STAFF RECOMMENDATION 2020 10th Avenue South June 19, 2019

Application: Demolition-Partial; New Construction—Addition
District: Waverly-Belmont Neighborhood Conservation Zoning Overlay
Council District: 17
Map and Parcel Number: 10509041200
Applicant: Seth Jennings
Project Lead: Melissa Baldock, melissa.baldock@nashville.gov

Description of Project: Application is for a two-story addition behind the historic one-story house. The project involves enclosing a side porch and altering window openings.

Figures 8 (left) is the front door frame, which is likely original. Figure 9 (right) is the drawing showing a different door frame and configuration.

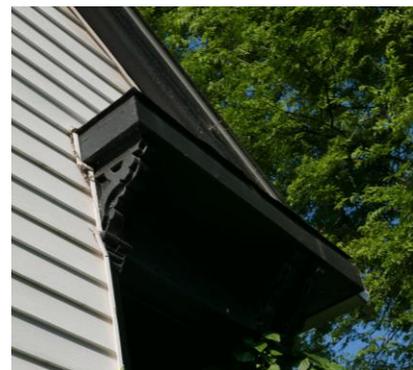
Partial Demolition: The applicant is proposing several changes to the historic house, which are partial demolition. On the front façade, the drawings show a different door frame configuration than what is extant (Figures 8 & 9). Staff finds that the arched transom and door frame are significant Italianate details that are likely original to the house and should be retained. However, the doorframe and transom do not appear on the drawings. Other details on the front porch and front façade, including the dentils and porch brackets, do not appear on the drawings and staff recommends that they be retained (Figures 10 & 11).

In conclusion, staff is supportive of the removal of the rear appendage at the back left side of the house, and is also supportive of the proposed alterations to the existing windows. However, staff finds that the alterations to the front door framing and other detailing do not meet Section V.B.2. of the design guidelines for appropriate demolition. Staff therefore recommends that a condition of approval be that the original detailing on the front and side façades remain, including but not limited to the door frame and transom, dentil details, porch brackets, and window frames.

1. The original detailing on the front and side façades remain, including, but not limited to, the door frame and transom, dentil details, porch brackets, and window frames;
2. The side porch enclosure include porch posts to look more like an enclosed porch;
3. The lap siding have a reveal of five inches (5”) or less and be smooth;
4. Staff approve the foundation material;
5. Staff approve all new windows and doors;
6. Staff approve the roof materials, colors, designs, and textures; and
7. Staff approve the location of the HVAC unit and all other utilities.

Figure 14. Staff finds that the removal of the appendage at the rear of the house to be appropriate.

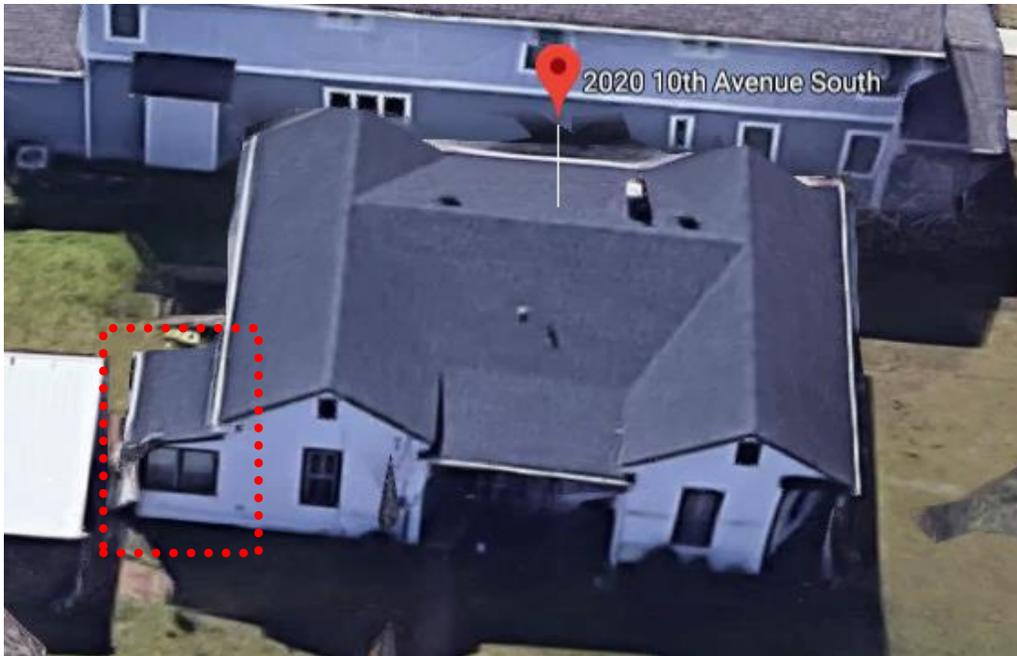
The applicant is proposing to remove a small, rear porch portion of the house (Figure 14). The rear porch of the house is not seen in any of the older maps for the house and was therefore likely constructed after 1957. The structure has a separate roof form from the rest of the house, and staff finds that its date of construction, location at the rear of the house, and roof form do not contribute to the historic character of the house.

Figure 15. The side porch that will be enclosed. .

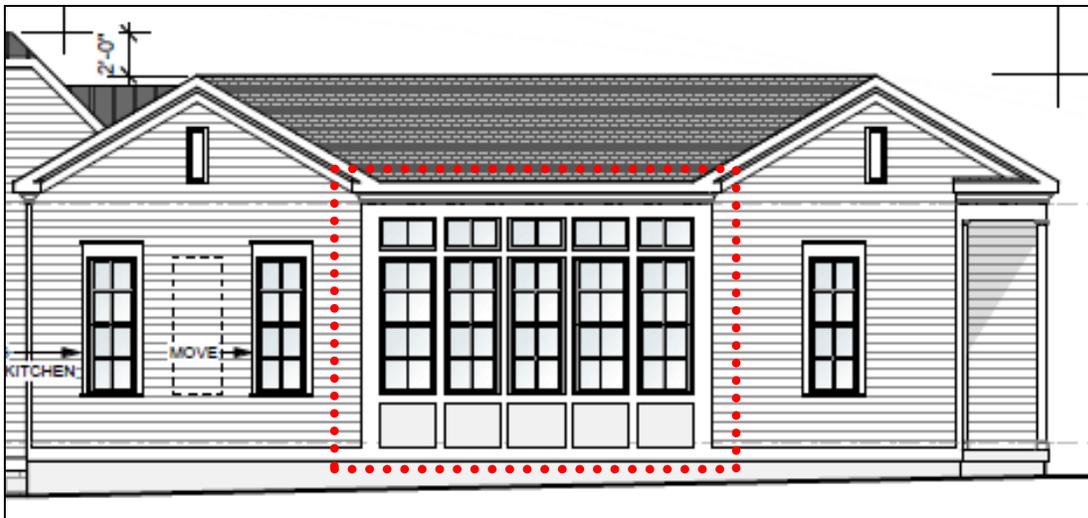
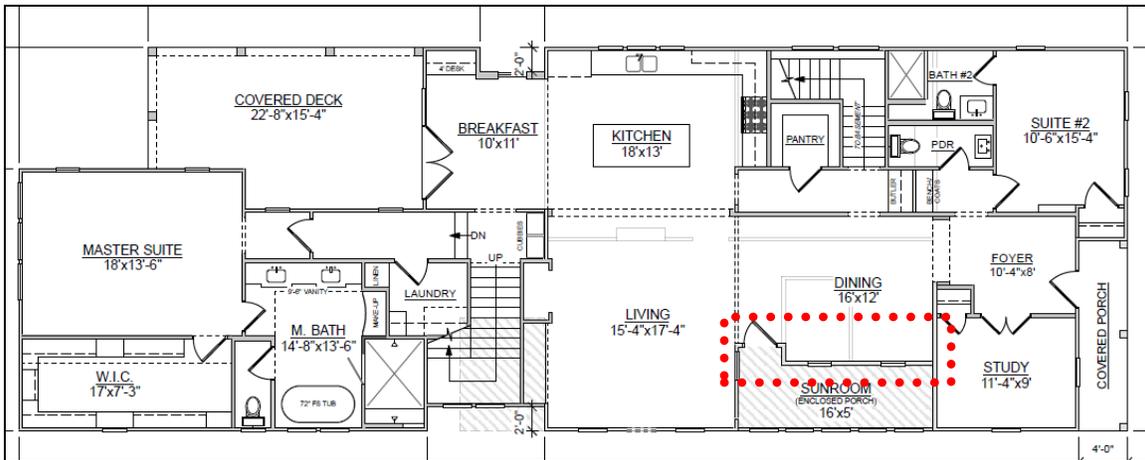
Design: Staff finds that the addition's height and scale are appropriate to the historic character of 2020 10th Avenue South. However, staff finds that the design of the proposed enclosure of the side porch is not appropriate (Figures 15, 16, and 17). Although the plans show that the exterior wall will remain, staff finds that the design of the enclosure lacks the transparency and openness required to indicate that this was once an open porch. The Sanborn maps from 1908, 1914, and 1957 all show that this area was always a side porch (Figures 18, 19, and 20). Staff finds the side porch configuration is a significant part of this historic house's form and should be preserved. Staff therefore recommends that the side porch element be designed look more like an enclosed porch with the addition of porch posts.

With the condition that the side porch enclosure include more glass or screens to look more like an enclosed porch, Staff finds that the project’s design meets Sections IV.A, IV.B, IV.C, and IV.F. of the design guidelines.

SITE PLAN
2020 10TH AVE S

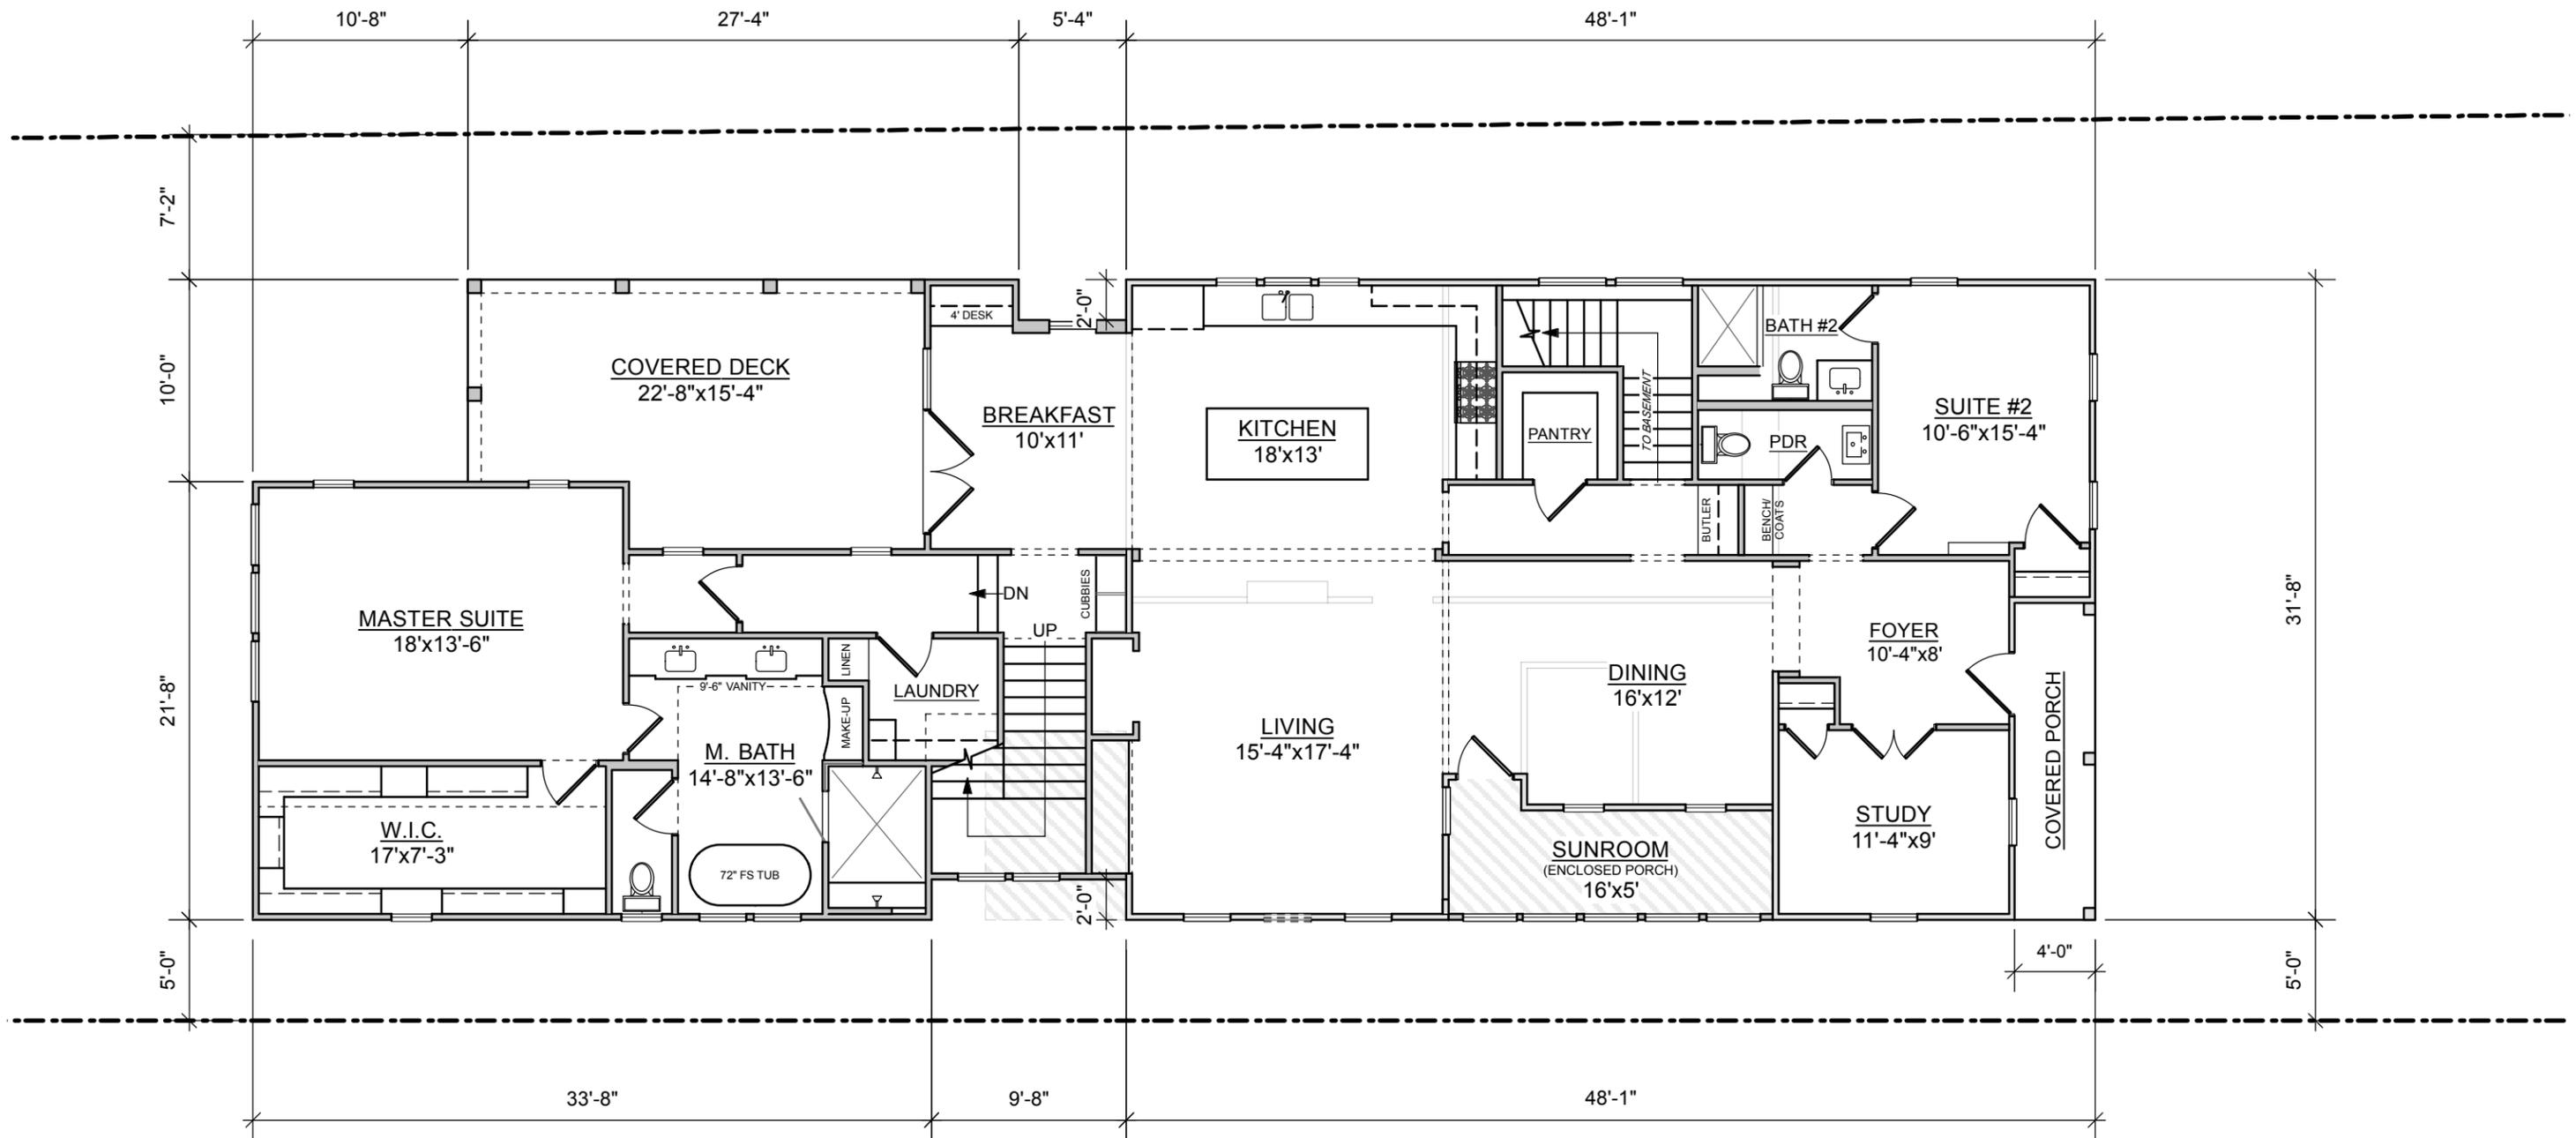
Setback & Rhythm of Spacing: The site plan shows that the addition meets all base zoning setbacks. It shows that the addition will be five feet (5’) from the left side property line and seven feet, three inches (7’3”) from the right side property line. It will be over fifty feet (50’) from the rear property line.

Although staff finds that the proposed setbacks as shown on the site plan are appropriate and meet Sections III.C. and IV. of the design guidelines, staff recommends that all future drawings show the accurate setbacks.
